**PLANNING DIVISION REPORT
DEPARTMENT OF PLANNING AND COMMUNITY
AND ECONOMIC DEVELOPMENT
December 1, 2008**

RE: L.D. # 12299: Zoning Map Amendment L.D. 3391, Demolition and Rezoning of 1308 West Dayton Street from R6 and C2 to PUD-GDP

REPORT OF: URBAN DESIGN COMMISSION	PRESENTED: October 15, 2008
TITLE: 1308 West Dayton Street – PUD(GDP), Union South. 8 th Ald. Dist. (12241)	REFERRED: REREFERRED: REPORTED BACK:
AUTHOR: Alan J. Martin, Secretary	ADOPTED: POF:
DATED: October 15, 2008	ID NUMBER:

DATE: November 17, 2008
TO: Plan Commission
FROM: Larry D. Nelson, P.E., City Engineer
SUBJECT: 1308 West Dayton Demolition and Rezoning

- "Current Metro Transit operations" diagram
- Sketch on site plan showing proposed bump-out on Campus Drive

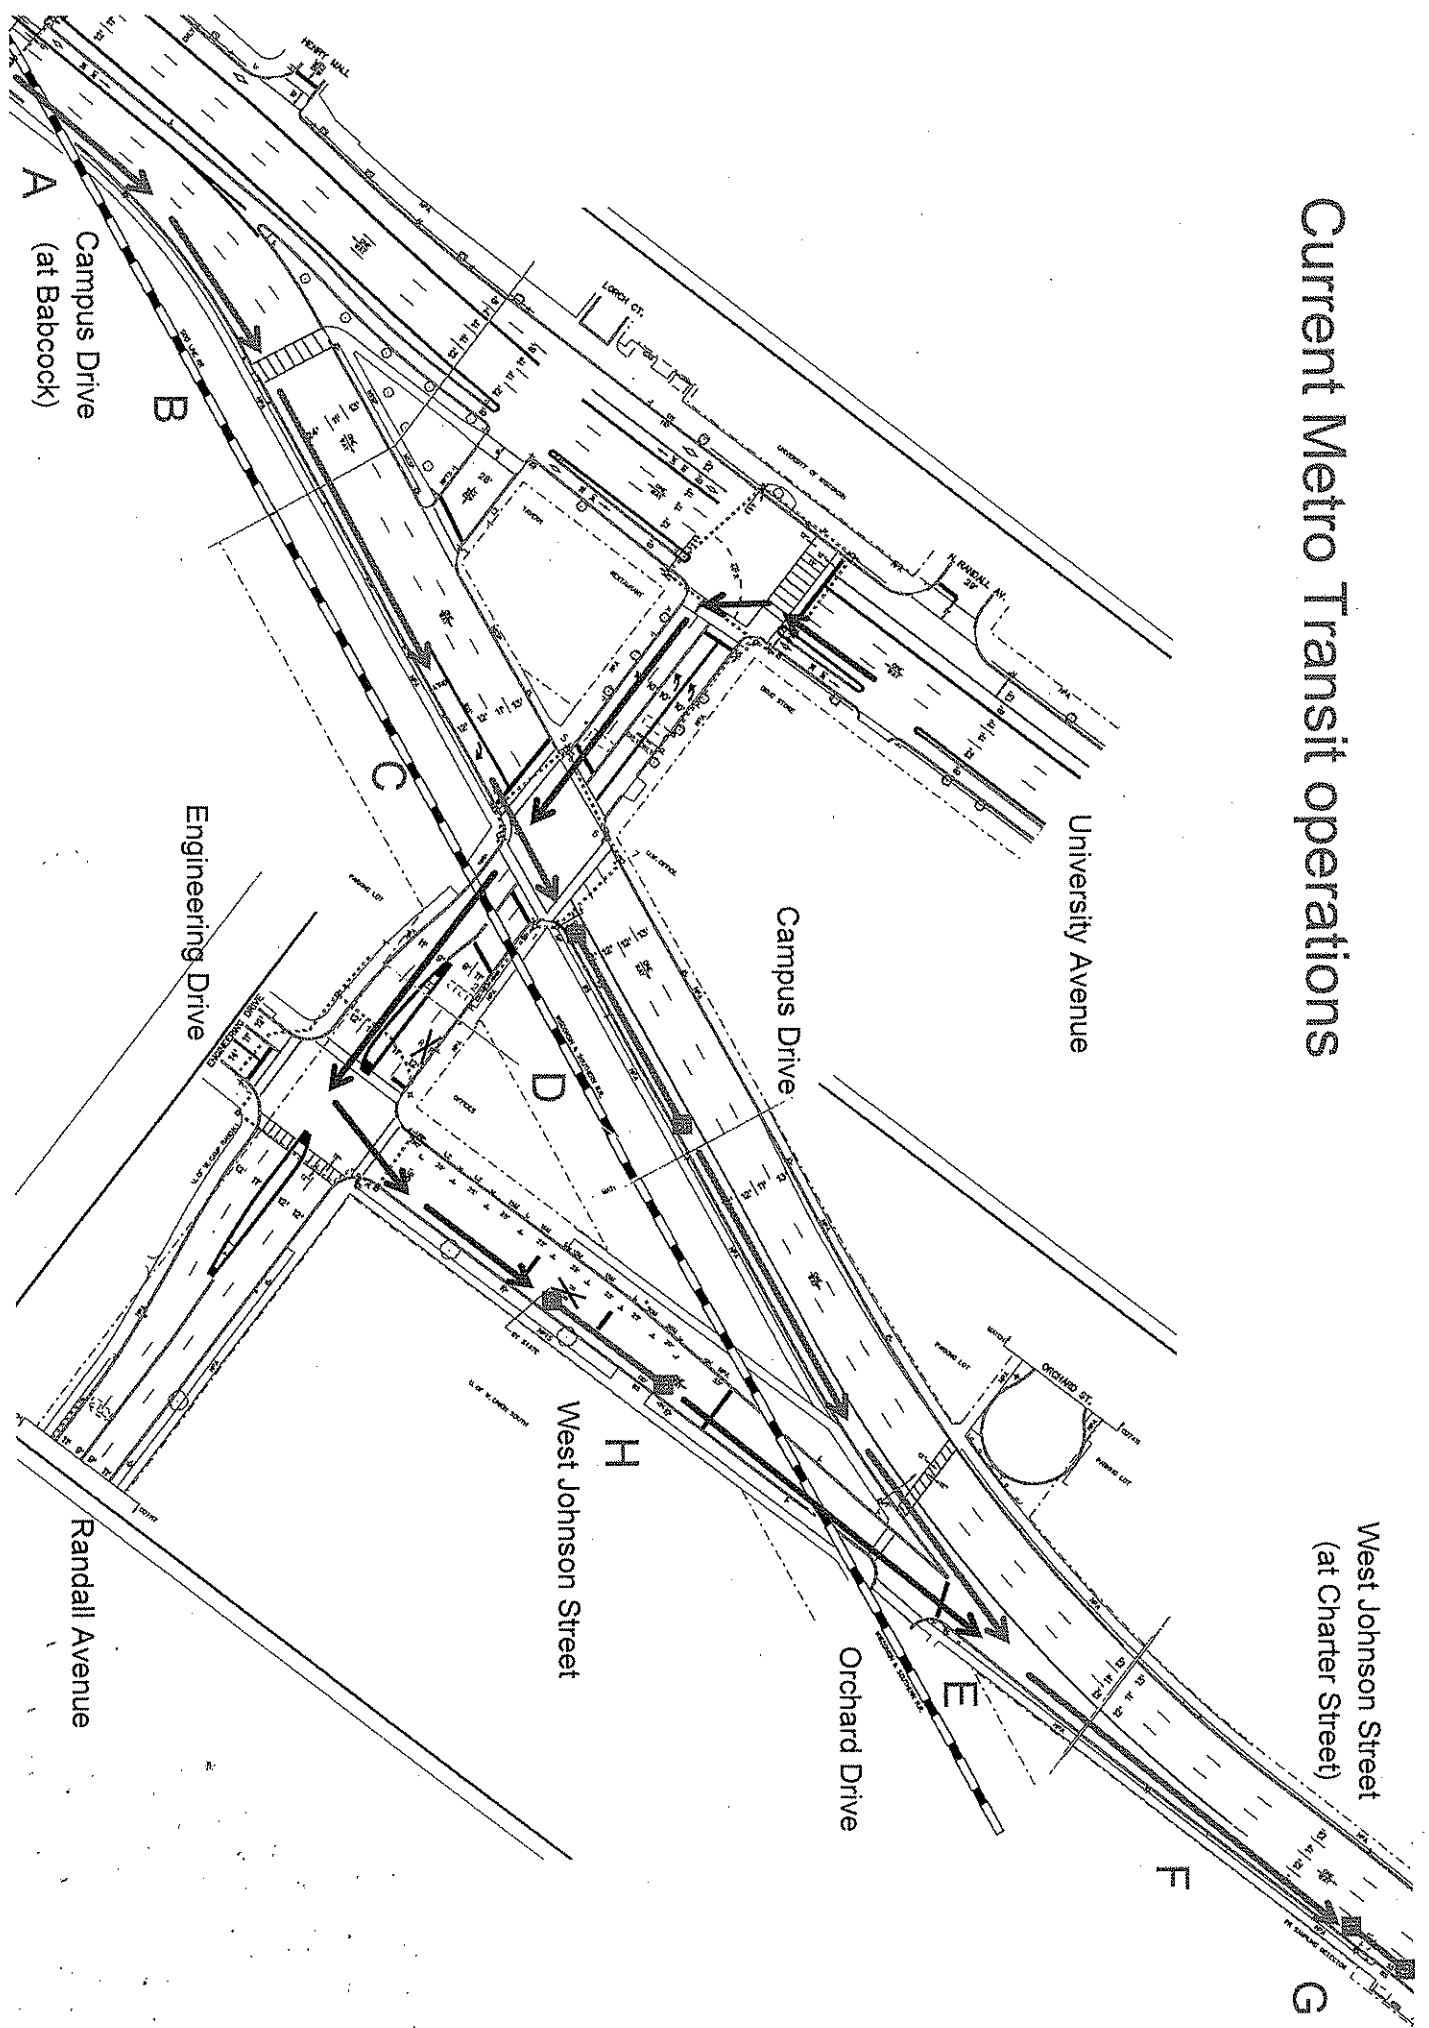
1. The proposed intersection configuration of Campus Drive and Randall Avenue shown on the site plans would eliminate the existing bus stop location on the south side of Campus Drive, east of Randall Avenue. This stop that would be eliminated serves the current Union South and adjacent properties, and would have otherwise directly served the proposed New South Campus Union, as well as the new WIDMIR site across the street. Elimination of this stop would also be contrary to the conceptual plans for the Transport 2020 commuter rail project, which anticipated direct passenger transfer opportunities between the train platform and local bus services at this stop location.

5. Metro Transit would request that the Plan Commission adopt a recommendation to the Board of Public Works and ultimately the Common Council in support of a physical traffic barrier being installed in the traffic lane on Campus Drive, that would create a safe bus stop zone near Orchard Street as identified in item 3 above.

the south curb line of Campus Drive (B), and approach the Randall Avenue intersection in the designated right turn only lane (C/[Image link](#)) that is added here (buses are exempt from this right turn requirement, which provides a travel time advantage for bus passengers to the extent the three through lanes of Campus Drive are more heavily congested). Buses continue straight through the intersection from this curb lane to the current bus stop location serving the Randall Avenue intersection and Union South area (D/[Image link](#)), which is delineated from the three through traffic lanes of Campus Drive by a solid white line. This dedicated lane marking allows not only a protected zone for loading and unloading the approximately 600 passengers per day who use this stop, but also affords buses a scheduled layover spot (as published in the Ride Guide bus schedules) and a location from which various routes can start trips (both instances where a bus may have occasion to park for three to five minutes before departing). The dedicated lane marking continues on Campus Drive through the current intersection with West Johnson Street, where traffic eastbound on West Johnson Street is required to yield to buses traveling along Campus Drive (E/[Image link](#)). Buses continue east towards their next stop as the lane marking transitions to a dashed line (F). The next bus stop is in the curb lane on the south side of West Johnson Street, west of Charter Street (G/[Image link](#)). The stop at Charter affords similarly important pedestrian access to the extent Charter Street extends north of University Avenue towards Van Hise Hall and Observatory Drive. In addition to the bus operations along Campus Drive, the UW Route 80 currently has evening trips that travel west of Charter Street along University Avenue and Randall Avenue to serve the bus stop location on West Johnson Street east of Randall Avenue (H/[Image link](#)). Buses make similar use of this location, as a protected stop zone, for scheduled layover and other short-term parking requirements (i.e. driver breaks).

8. Elimination of the bus stop on Campus Drive east of Randall Avenue would leave an approximately 1/8th mile or 700 foot walking distance from the project site back to the previous stop location near Babcock Drive. The walking distance from the northeast corner of the development parcel (West Johnson Street at Orchard Street) to the next bus stop at Charter Street would be approximately 350 feet. The distance between these two remaining bus stop locations at Babcock and Charter (due to the elimination of the stop at Randall) would be just over 1/4 of a mile in total.
9. Metro Transit requests to sign and review final documents submitted for this project.
